Access Compliance Report

Public Rights-of-Way

Intersection ID: 2912	Main Street: CRYSTAL_LEAF_PL	Cross Street: FOREST_PATH_DR	Location:	N
ADA ID: 97F779223EE3	Ramp Type: Perp	Initial Pass/Fail: Fail	Overall Compliance: No	Severity Score: 13.75
Codes/Mitigation Info/Possible Solution		Field Measurements/Component Compliance

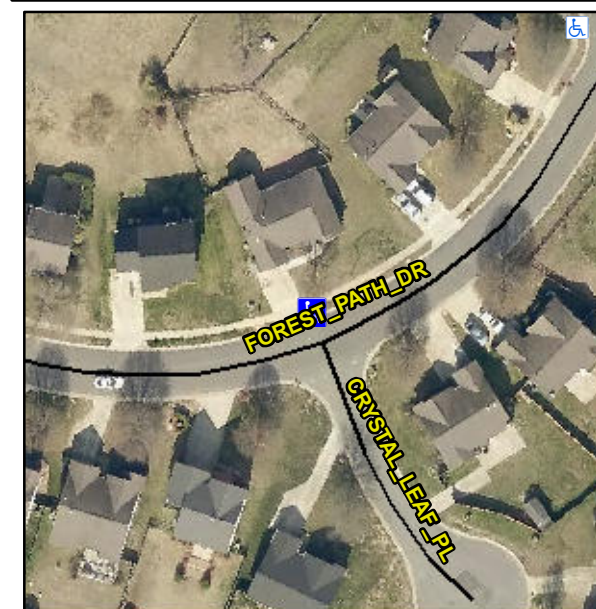
Compliance	Description	Data	Compliance	Description	Data
N/A	Ramp Length (in)	48.0	No	Ramp Slope (%)	11.5
Yes	Ramp Width (in)	53.0	Yes	Ramp XSlope (%)	2.2
N/A	Flare Type LT	N/A	N/A	Flare Type RT	N/A
N/A	Flare Slope LT (%)	N/A	N/A	Flare Slope RT (%)	N/A
N/A	Flare Traversable LT?	N/A	N/A	Flare Traversable RT?	N/A
N/A	Landing Length (in)	N/A	N/A	DWS Provided?	N/A
N/A	Landing Width (in)	N/A	N/A	DWS Contrast?	N/A
N/A	Landing Slope (%)	N/A	N/A	DWS Length (in)	N/A
N/A	Landing X Slope (%)	N/A	N/A	DWS Full Width?	N/A
N/A	Landing Curb? (Y/N)	N/A	N/A	DWS Offset (in)	N/A
N/A	Shared Landing?	N/A			
N/A	Gutter Ponding?	N/A	N/A	Gutter Slope (%)	N/A
N/A	Gutter Lip Ht (in)	N/A	N/A	Gutter X Slope (%)	N/A
N/A	Painted X Walk1?	No	N/A	Painted X Walk2?	N/A
	X Walk 1 Direction	To S		X Walk 2 Direction	N/A
N/A	X Walk 1 Width (in)	N/A	N/A	X Walk 2 Width (in)	N/A
	X Walk 1 Slope (%)	N/A		X Walk 2 Slope (%)	N/A
	X Walk 1 X Slope (%)	N/A		X Walk 2 X Slope (%)	N/A

N/A	Ramp inside XWalk1?	N/A	N/A	Ramp inside XWalk2?	N/A
	Road Slope (%)	1.1	N/A	Clear Space?	N/A
	Road X Slope (%)	11.9	N/A	Clear Space to XWalk (in)	N/A
N/A	Any Obstructions?	N/A	N/A	Storm Grate/Utility Hazard?	N/A
	Obstruction Type			Storm Grate/Utility Type	
		N/A			N/A
			Yes	Surface Condition? (G/P)	Good

Remove & Replace Entire Ramp.
